**TOWN OF OCEAN RIDGE
PLANNING & ZONING REGULAR MEETING
AGENDA**

To:	Planning & Zoning Board Members
From:	Corey O’Gorman, Town Planner
Meeting Date:	July 21, 2026
Subject:	5920 N Ocean Blvd – Development Plan Review

PLAN REVIEW REPORT
5920 N Ocean Boulevard
05/06/2026 – 06/04/2026 – 07/14/2026

ASIR RESIDENCE
MAY 2026 TOWN PLANNER COMMENTS — COMPLIANCE RESPONSE
03 / 08

Sheet: east and west elevations

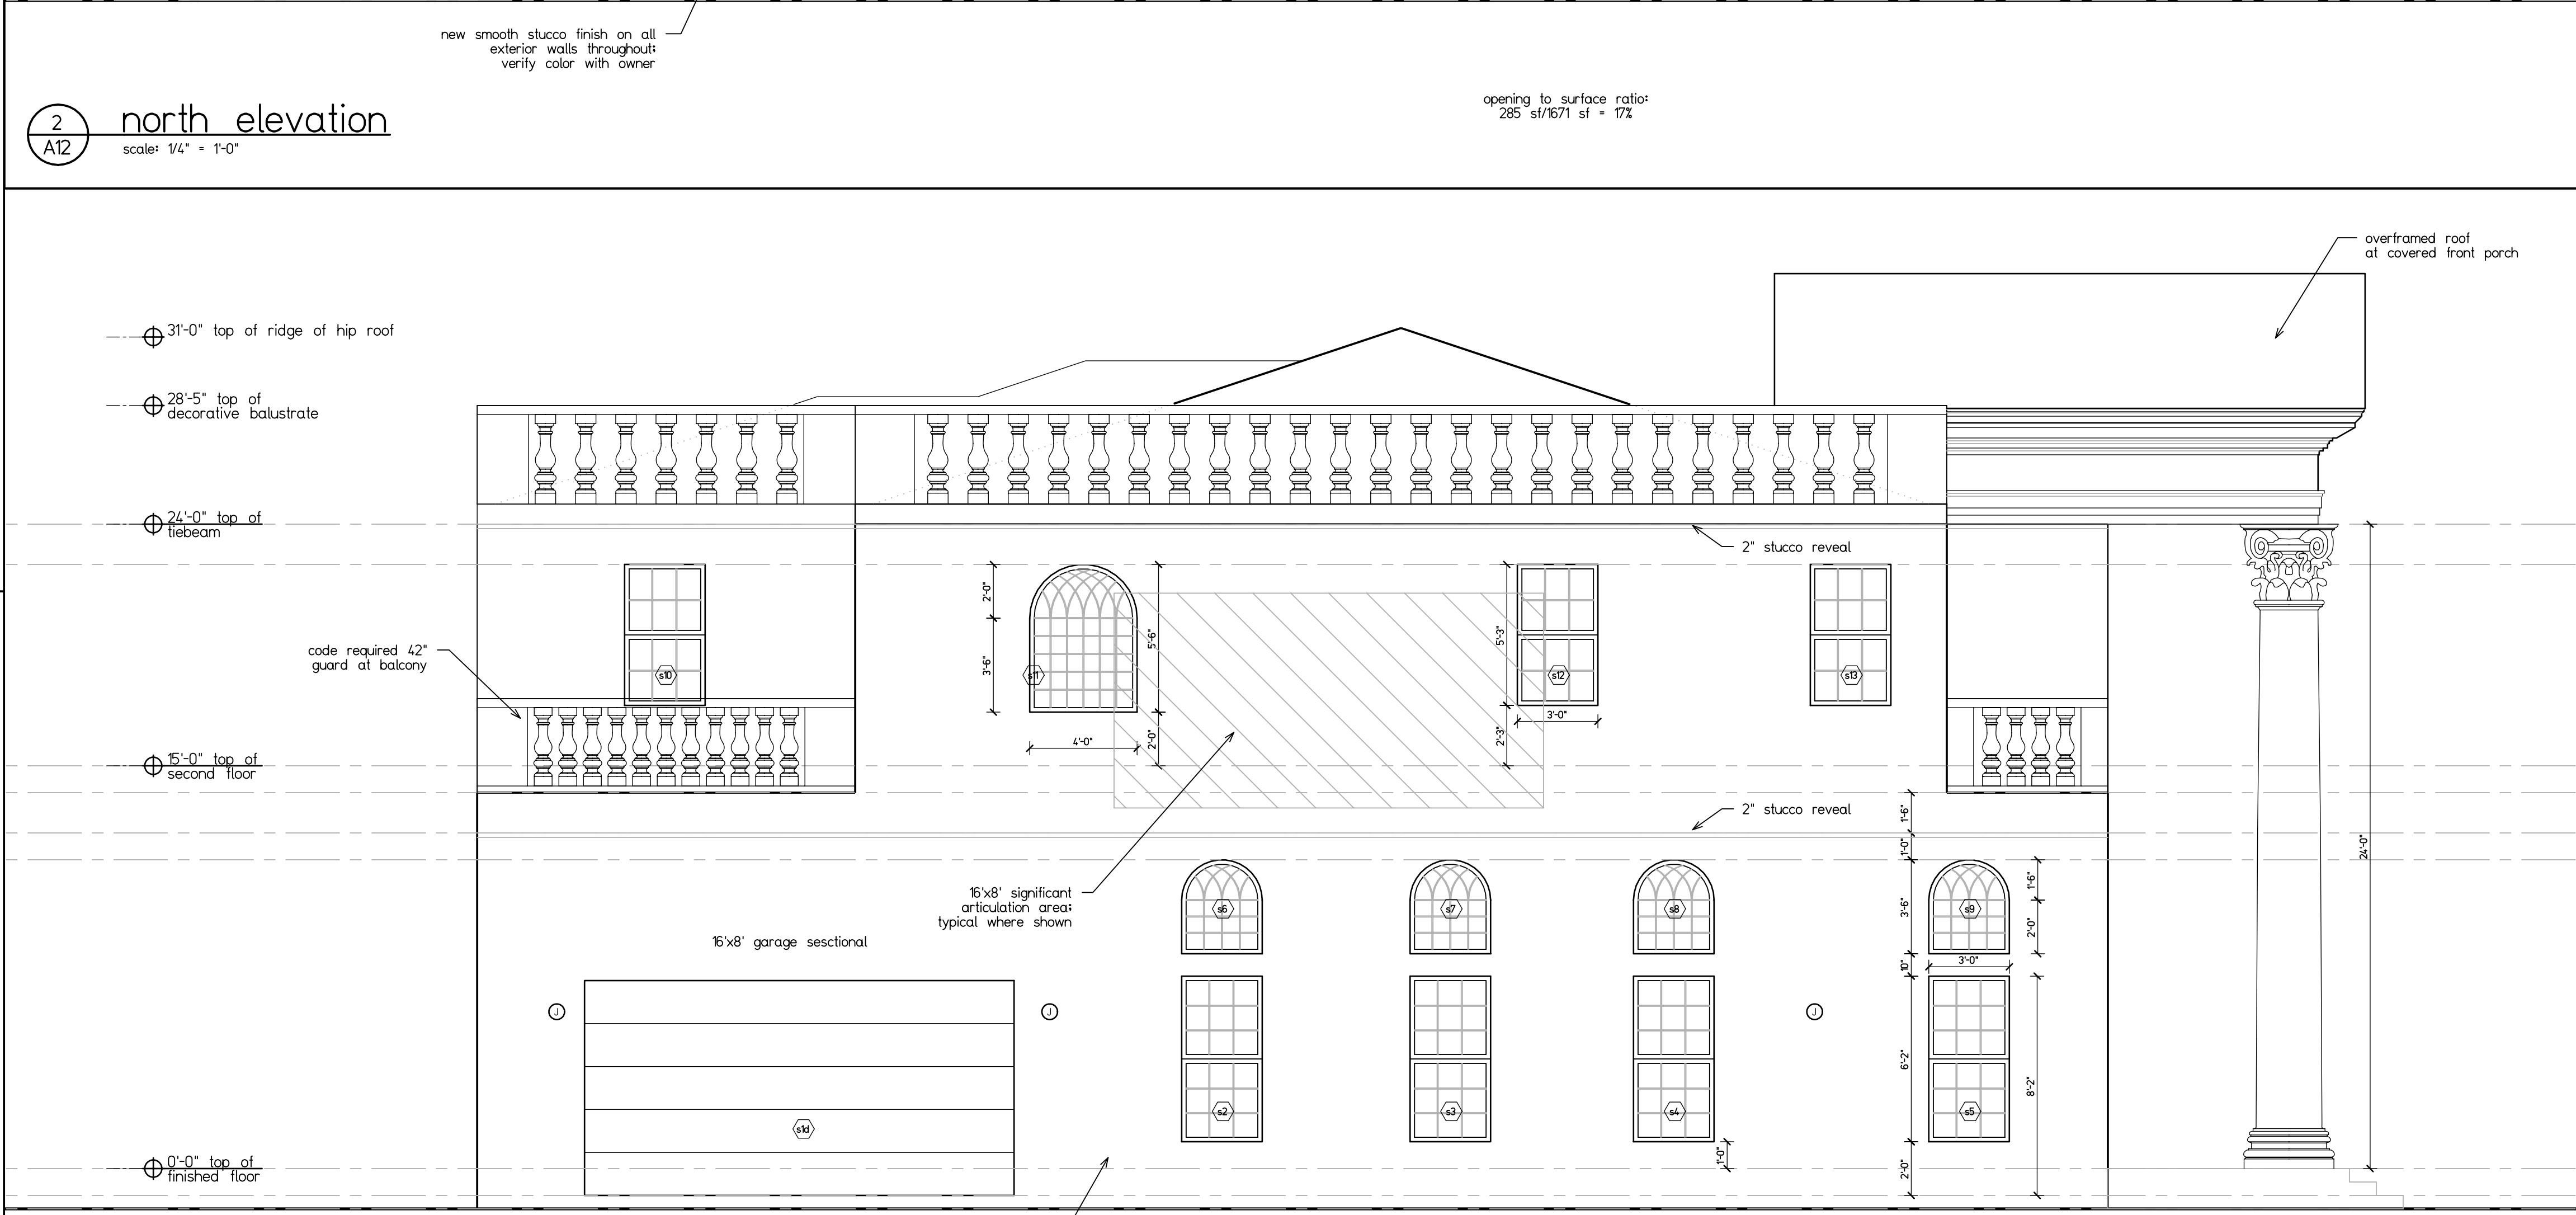
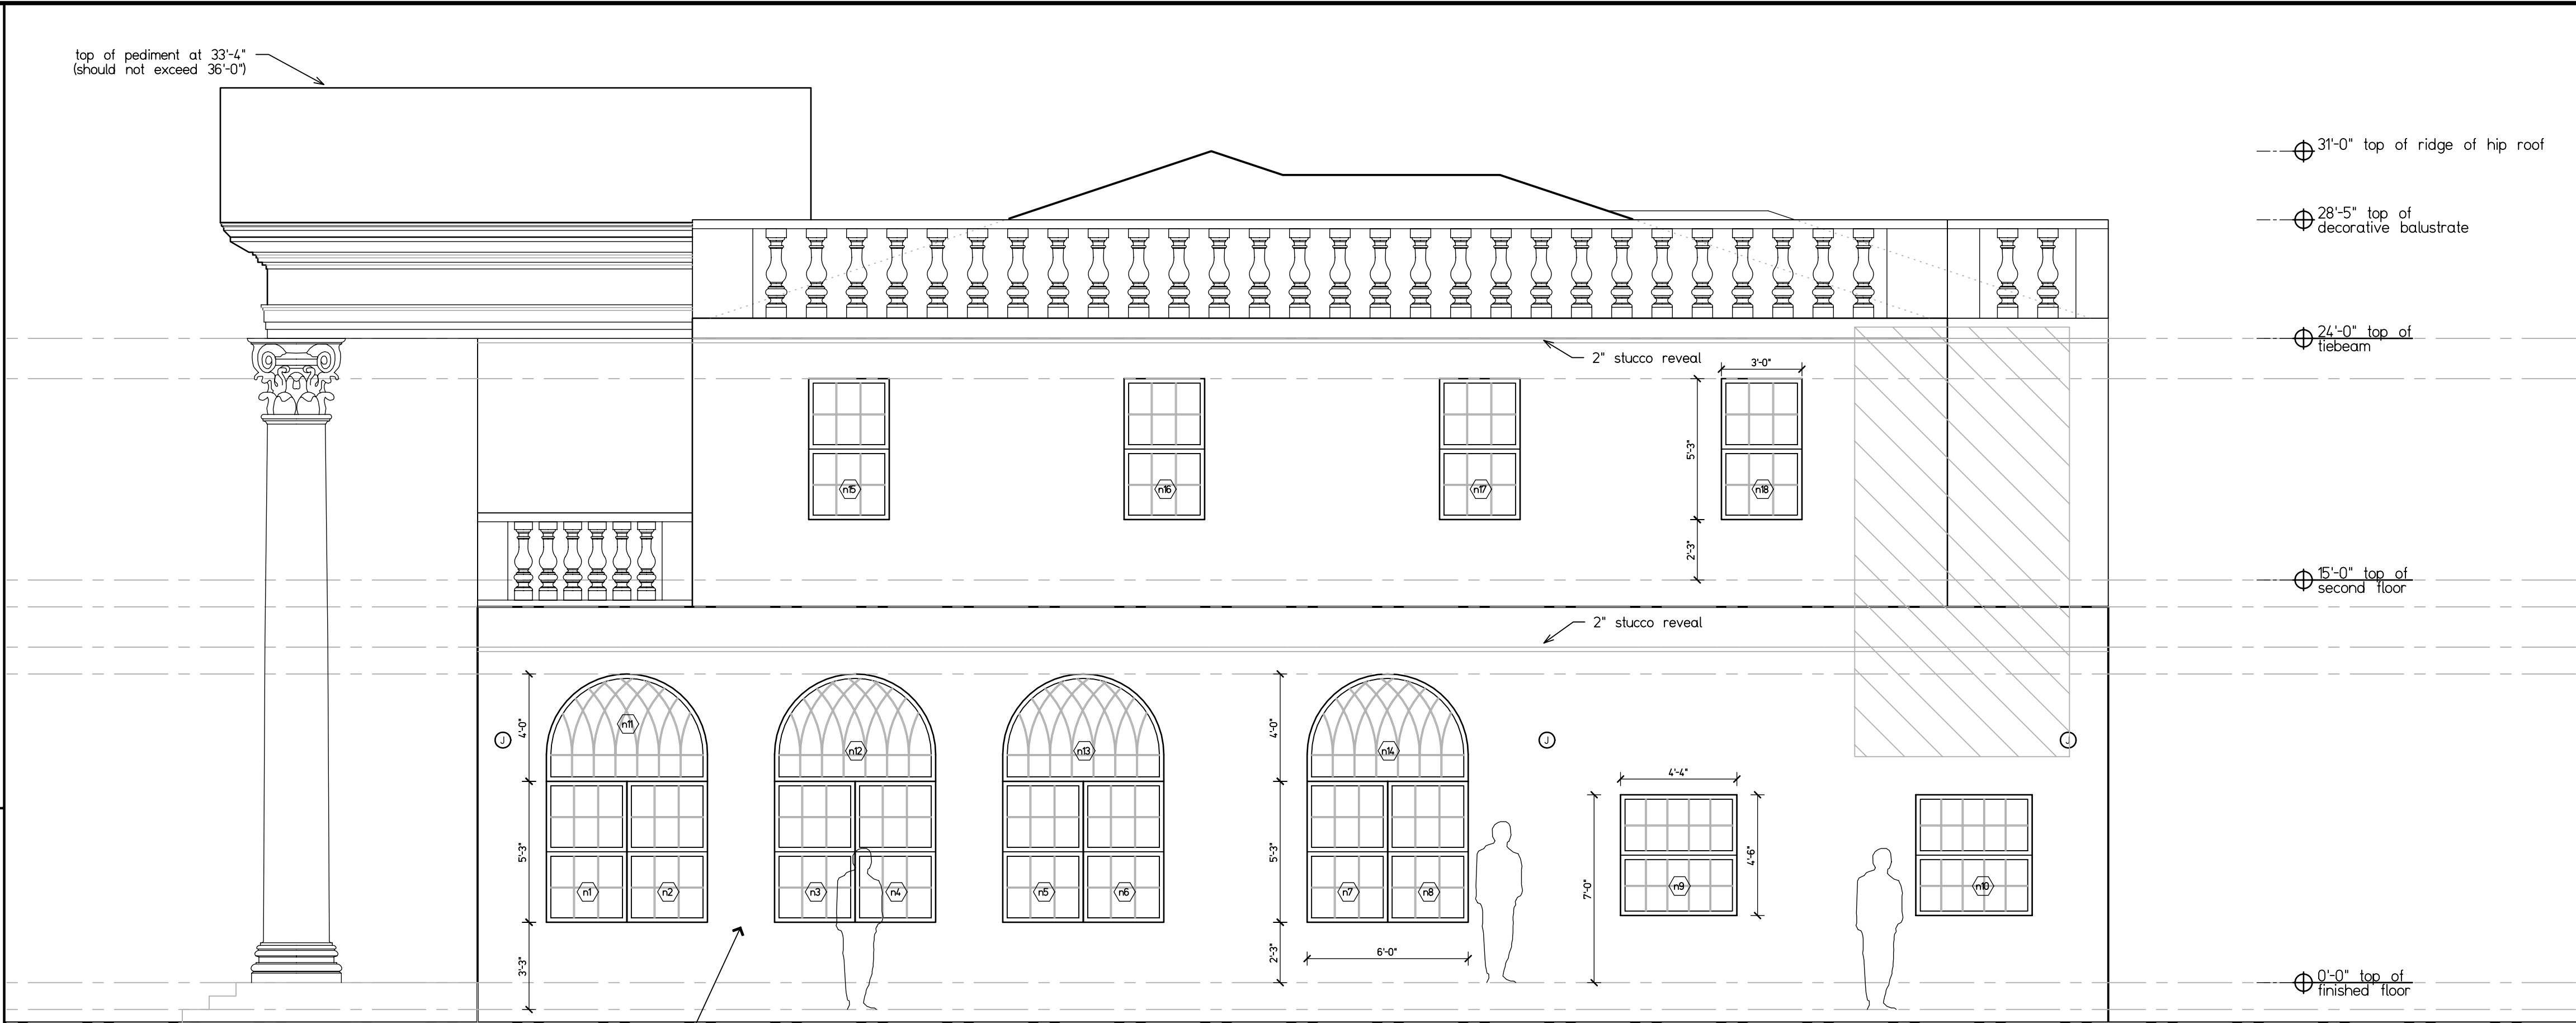
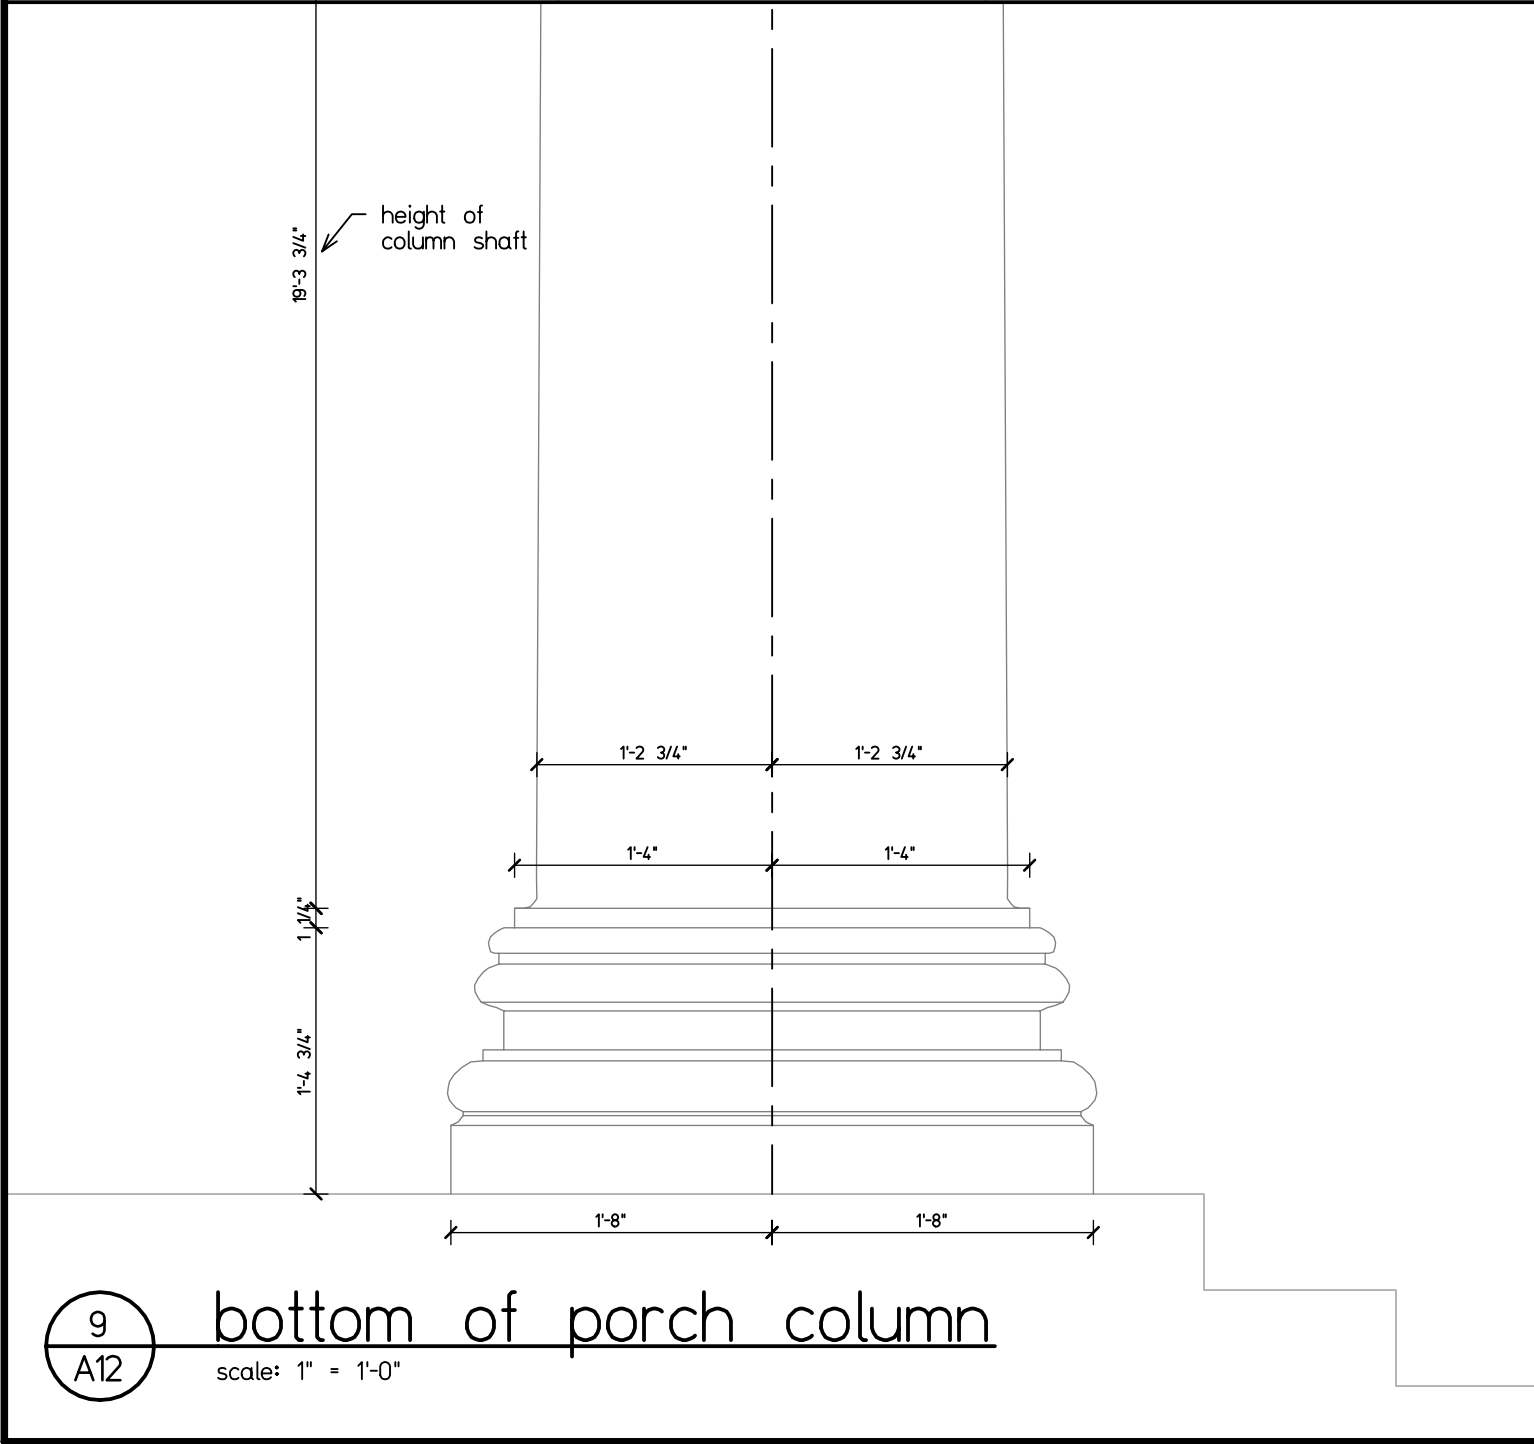
~~Comment: Please revise elevation sheets A11 and A12 to provide the calculations necessary to ensure compliance with the 15% requirement.~~
Comment addressed.

Comment: Please revise sheets A11 and A12, and other sheets as applicable to comply with the maximum height requirements in this code section. ~~Comment not addressed. As noted above, Section 64-1(f)(2) allows flat roofs provided that they comply with the requirements of Section 67-37. Section 67-37 limits the tie beam to 24' and requires a parapet which shall not extend more than 32" above the tie beam to screen any rooftop element as such the maximum overall allowable building height for a flat roof is 26' 8".~~

Calculations have been added directly to elevation sheets A11 and A12, confirming that all four building elevations meet or exceed the required 15% window and door opening coverage.

The north elevation has been revised accordingly. The proposed window trim, door trim, and decorative emblem do not extend beyond the plane of the existing encroachment wall. Articulation is achieved through recessed banding and stucco score lines flush to the wall face. Revised sheets A11 and A12 reflect this treatment.
